ANSWER A QUESTIONS ASKED BY A POTENTIAL BIDDERS AND TO PROVIDE ADDITIONS/DETAILS TO SPECIFICATIONS AND PLANS.

5P300-16-5377 Demolition and Complete Reconstruction of M Bridge of Les Cascades Trail

ADDENDUM 1

DÉTAIL DU GARDE-CORPS
1:20

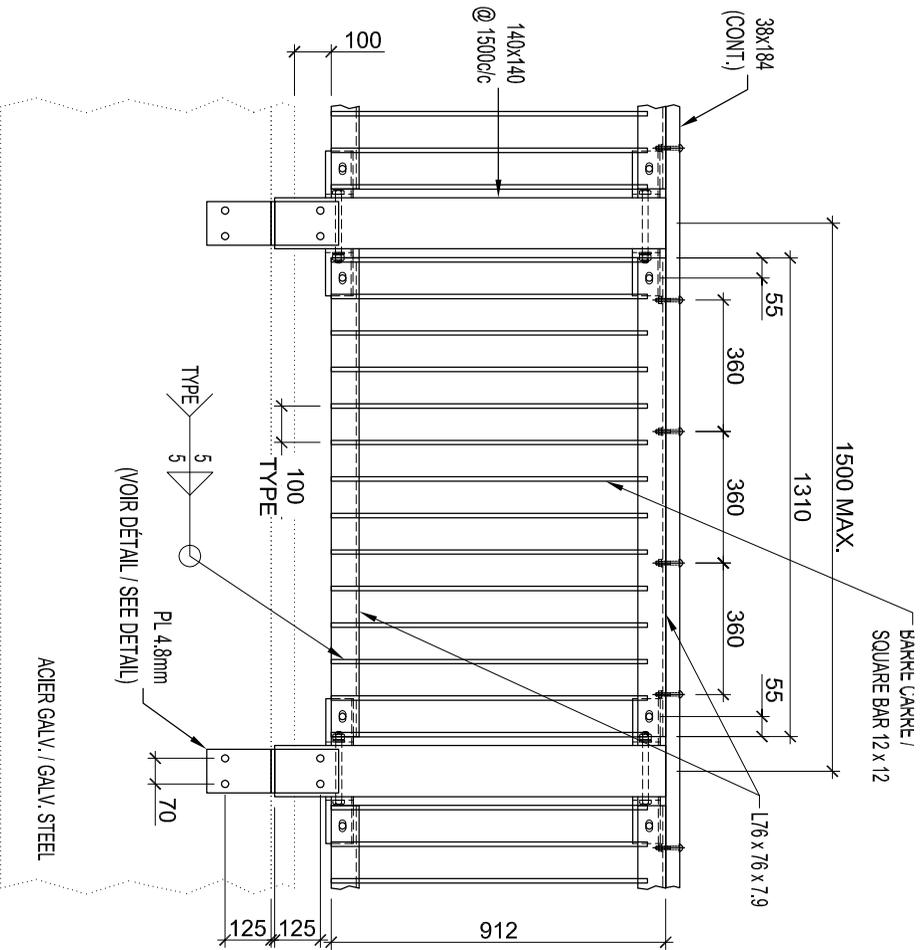
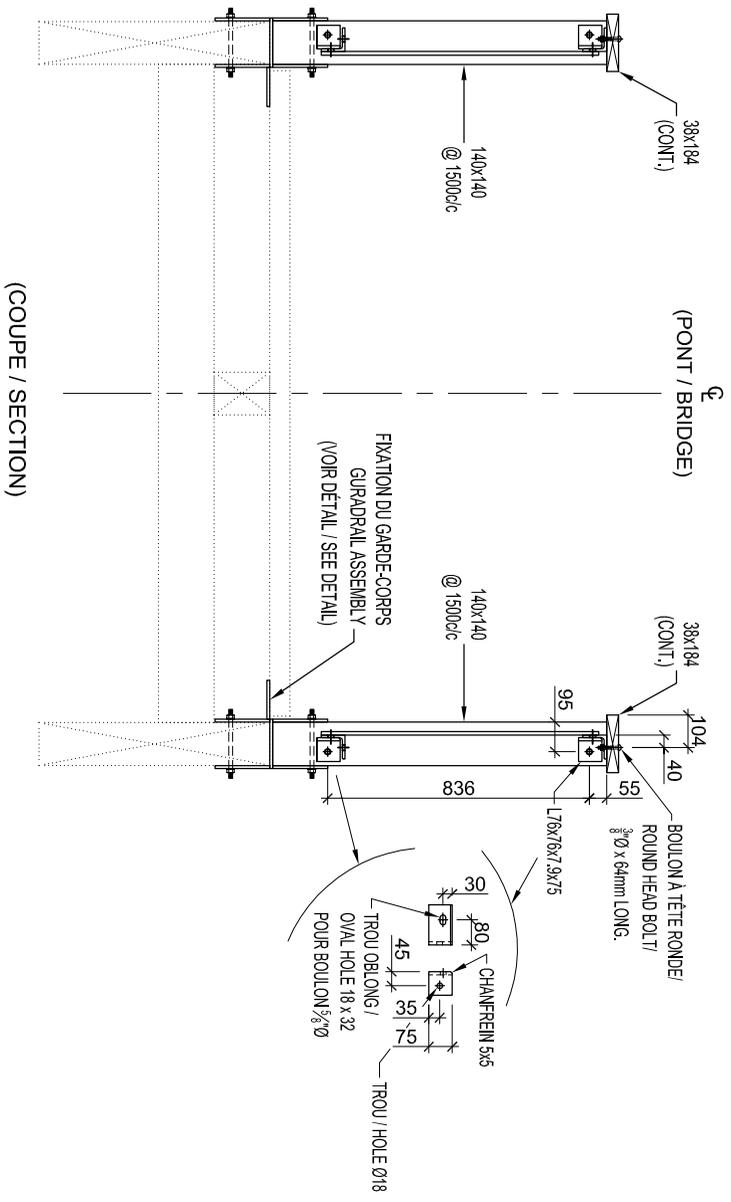
Modification to the sheet 301 by the sketch AD-ST01-04

The railing is changed. A galvanized steel section replaces the wooden pickets.

PLAQUE DE FERMETURE
END PLATE DETAIL
1:20

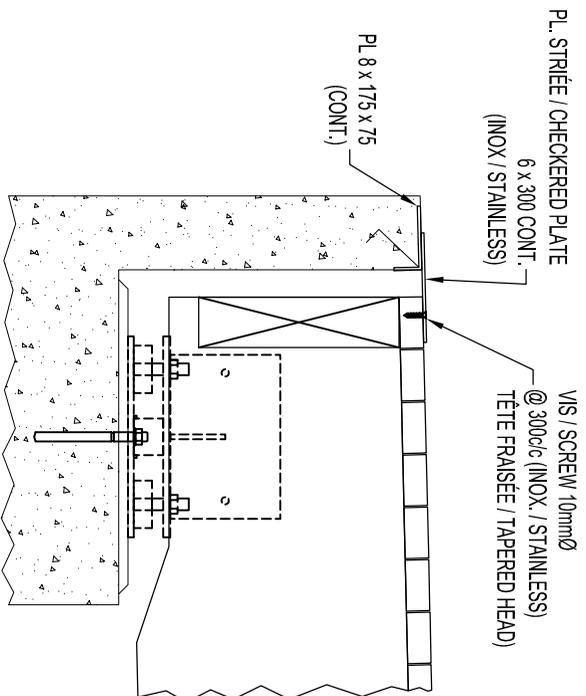
Modification to sheet 401 by the sketch AD-ST01-01

A closure plate is added to the ends of the decking.

ASSEMBLAGE C1 - G1 - P3

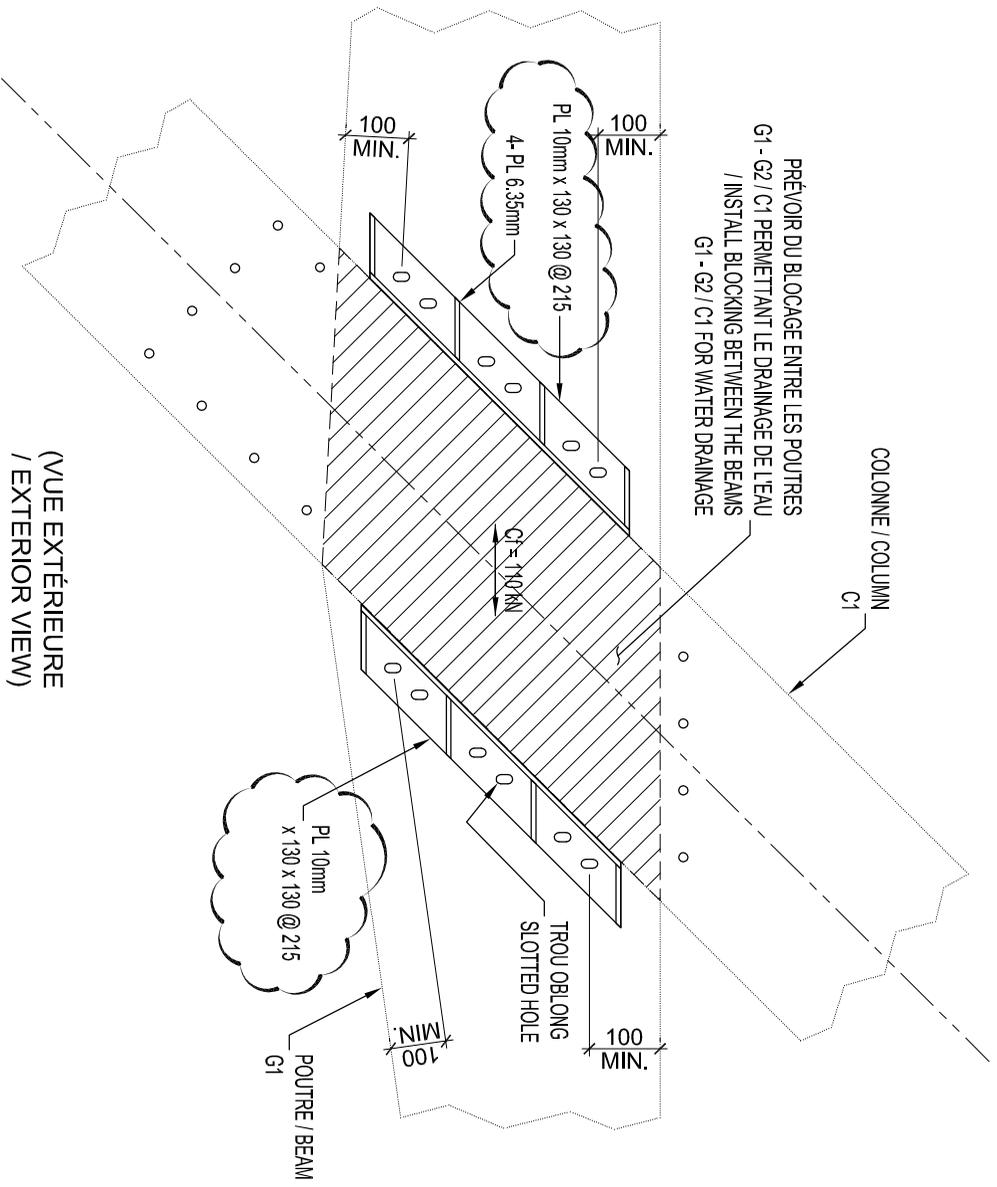
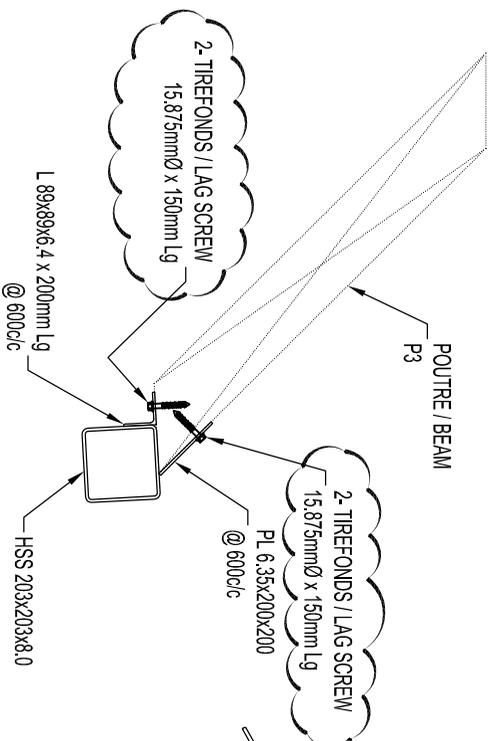
Modification to sheet 402 by the sketch AD-ST01-02

Modification to the assembly as shown on the sketch.
